Mesa Public Library Noise Issues

Level 2 Meeting Rooms

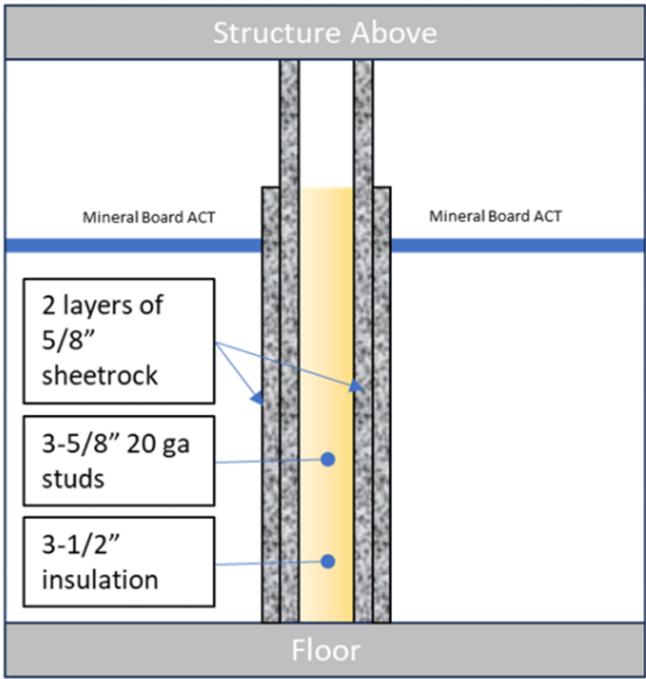
- Sound transmission between adjacent rooms when the operable partition are in use is poor.
- Speech intelligibility between meeting rooms relates to both the audibility of the intruding sound and the intelligibility of the speech itself.
- Eliminating the sound transfer entirely is not feasible with an operable wall.
- Over time the seals on the operable walls can become misaligned or degrade and no longer seal.

- It is recommended that the library contacts its local folding partition vendor (Modernfold is installed) to perform a maintenance inspection and to verify the integrity of the seals and wall panels.

- If this evaluation does not yield any noticeable improvements the we recommend that the replacement of the existing partitions be considered.
- If replacement is the path forward, a newer option providing a higher level of sound isolation can be selected.

- We recommend that a partition with an STC-53 or better be selected.
 - This can be the Moderco Signature 800 or the Modernfold Encore
 - It should be noted that although operable partitions can be rated above an STC-50 they often perform 5-7 point lower than their STC rating once installed, due to various in-field conditions.

- The alternative is to replace the folding partitions with a fixed wall assembly. Although this would eliminate the flexibility of the space, the STC-55 assembly will achieve a superior level of acoustic noise reduction as compared to an operable wall.

Level 1 – Group SC Room & Small Study/Phone Rooms

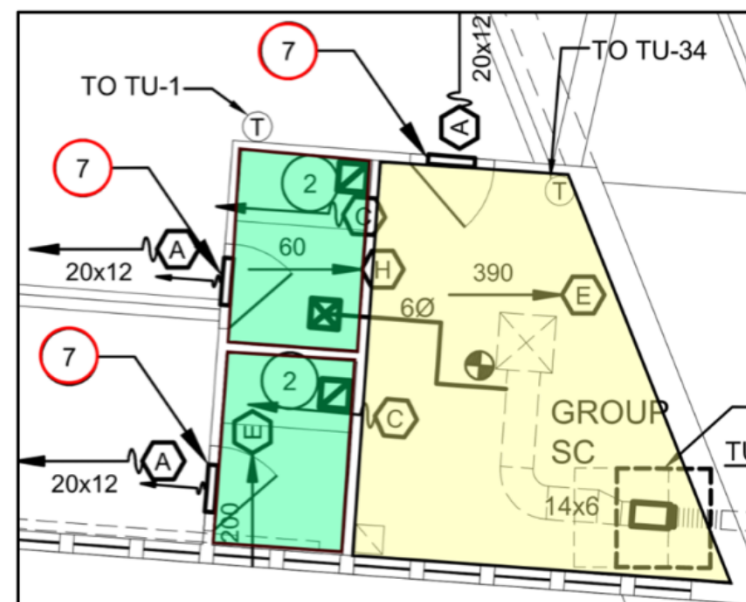
- **Group SC Room:** Elevated temperatures have occurred in this room prompting an increase in airflow to improve cooling. However, the added air volume is resulting in higher background noise levels in the room.

- **Inter-room Noise Transfer:** Sound is transferring between adjacent rooms. This occurs through 2 primary paths.
 1. Directly through the wall structure, which is dependent upon the performance of the assembly. (STC rating)

2. Indirectly through the ceilings, where sound travel through the ceiling, over the top of the wall, and then enters the adjacent space through the ceiling of the neighboring room. (CAC rating)

- **Noise Leakage to Public Areas:** Sound from the enclosed rooms is also escaping into adjacent public spaces via the return air openings located in the walls. These openings are shown as red circled “7” in the layout. The return air openings are located within the walls or doors below the room’s ceiling plane.

Level 1 – Lisa Rivera's Offices

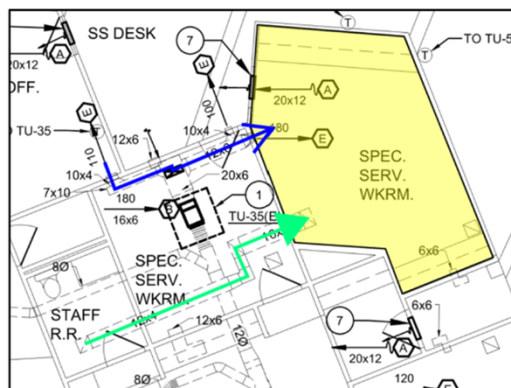
- This office features an open ceiling design with exposed wood framing.
- **Loading dock door noise:** A squeaking sound is consistently heard from the operation of the loading dock door located directly beneath the office.

- **Airborne Sound Transmission:** Noise is also transferring into and out of the office through the wall mounted return air opening.

- It is suggested that WD-40 or similar be applied to the loading dock door hinges.
- **Intermittent Loud Disturbances:** On occasion, loud noises resembling someone screaming have been heard. Most likely this is occurring through the duct path that is connected to adjacent rooms, such as Staff Restrooms or the OC Office.

- It is suggested that a 5-foot section of duct connecting the office to the restroom and the OC Office be internally lined with fiberglass ductliner. Alternatively, this section of duct can be replaced with 5-foot-long insulated flex duct.

Level 1 Mitigation Options – Noise Transmission Between Rooms

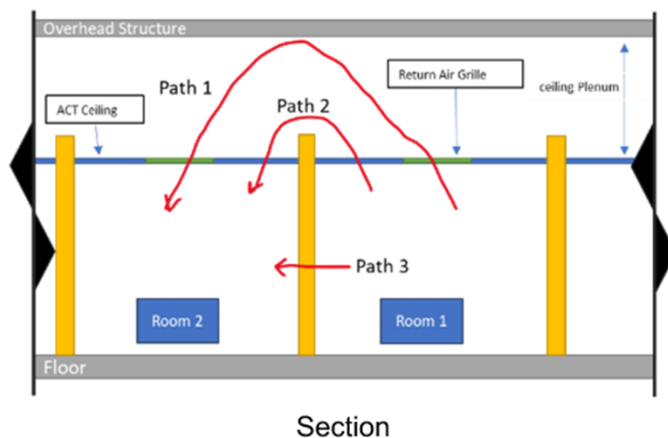
- Existing walls in most rooms were determined to be constructed using 1 layer of sheetrock on each side of 3-5/8" metal studs with no insulation in the stud cavity. This wall performs around an STC-35 to STC-40.
- Walls are partial height and stop above the ceiling.
- The ceilings appear to be a mineral board ceiling tile which performs around a CAC-30 to CAC-35.
- With the open return grilles in the ceiling located close to one another, the performance through the ceiling is expected to be reduced. Therefore, the combined architectural separation between rooms is expected to be around an STC-35.

- Path1:** Through the return air opening into the ceiling plenum and back down through the return air opening into Room 2
- Path2:** through the ACT tile into the ceiling plenum and back down through the ACT tile into Room 2
- Path3:** through the body of the wall

Ground Level – Tech Services Work Room

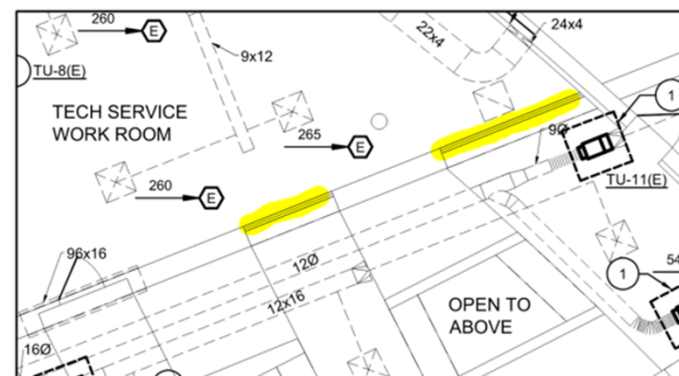
- Although this Level 1 office is currently vacant, the reported noise issues involves conversation within the space being audible in the adjacent public areas.
- Sound is easily passing through the single-pane wall mounted window.
- This window is now permanently sealed.
- Staff in the workroom can hear kids from the Children Collection Area through the single pane windows, highlighted in yellow.

- If the window is no longer needed, remove it and fill in the opening to match the wall's constructed assembly.
- If the window is still needed, replace it with a double pane window consisting of 1/4" glass_1/2" airspace_1/4" glass
 - This glazing assembly is expected to improve sound isolation by approximately 10 dB compared to the existing glass, effectively reducing the noise transmission by half.

Ground Level – Young Adult Reading Area

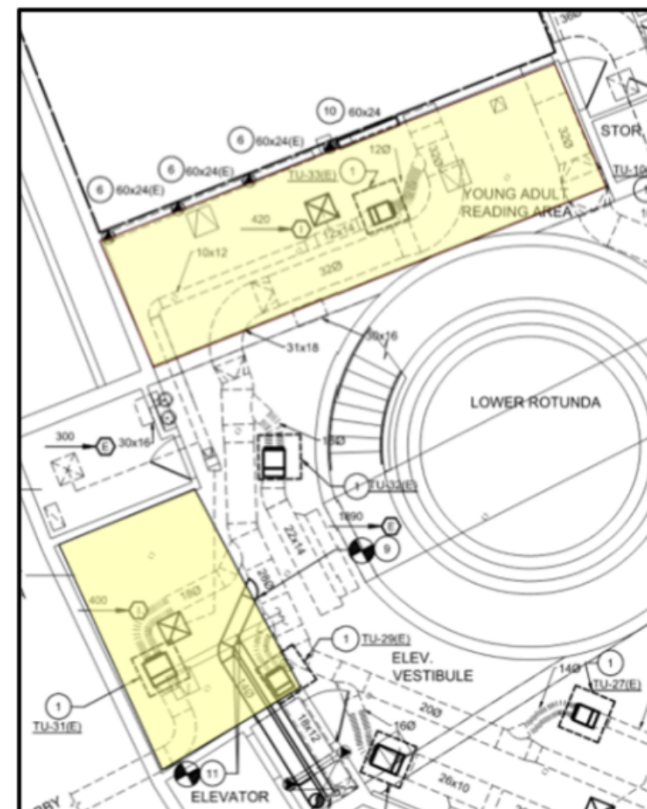
- Elevated background noise levels are present within the areas shown in yellow.
- This appears to be due to excessive airflow. When standing in these locations, one can feel a strong air current and observe nearby decoctions visibly moving, indicating high velocity air movement in the space.

- The background noise levels was measured to be 59 dBA (NC-52) which is substantially above the recommended background noise level of library reading zones of 35 dBA (NC-30).

- The Test & Balance Report dated February 25, 2019 was reviewed as part of this investigation and was assumed to be the final version.
- However, upon examination, several items listed on pages 8-10 remain unresolved. These include:

- Terminal units TU-33 and TU-31, located above the Reading Area per plans, are reported as balanced to maximum airflow rates of 1120 cfm and 2195 cfm respectively.

- But based on the pronounced airflow and movement of hanging elements in this area, it is likely that the actual airflow and associated airflow velocities in these zones are exceeding the reported values.

- It is also conceivable that the air reaching the Group SC Room on Level 1 is impacted by the amount of air being lost over the Youn Adult Reading Area, resulting in less air available to cool this room and possibly other rooms in the library.

Sound Travel through the Rotunda

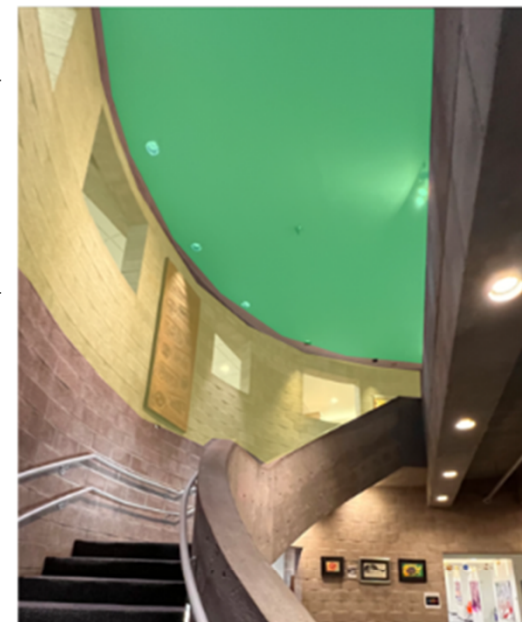
- Children's events are internally scheduled outside of regular business hours to minimize the noise impact on library patrons.
- The event was clearly audible through the rotunda during our visit and into the surrounding areas on all three floors indicating significant vertical and lateral sound transmission

- A noise test was conducted while onsite using a speaker positioned on the ground floor of the rotunda and set to generate white noise. This test was used to evaluate how sound attenuates as it travels vertically through the rotunda.

- Sound levels were measured on the ground floor, Level 1, and Level 2.
- RESULTS:
 - 6 dB reduction in noise between the ground floor and Level 1
 - 25 dB reduction in noise between the ground floor and Level 2

- This is consistent with our observations as the rotunda is more acoustically open between the ground floor and Level 1 as compared to the single door connecting Level 2.
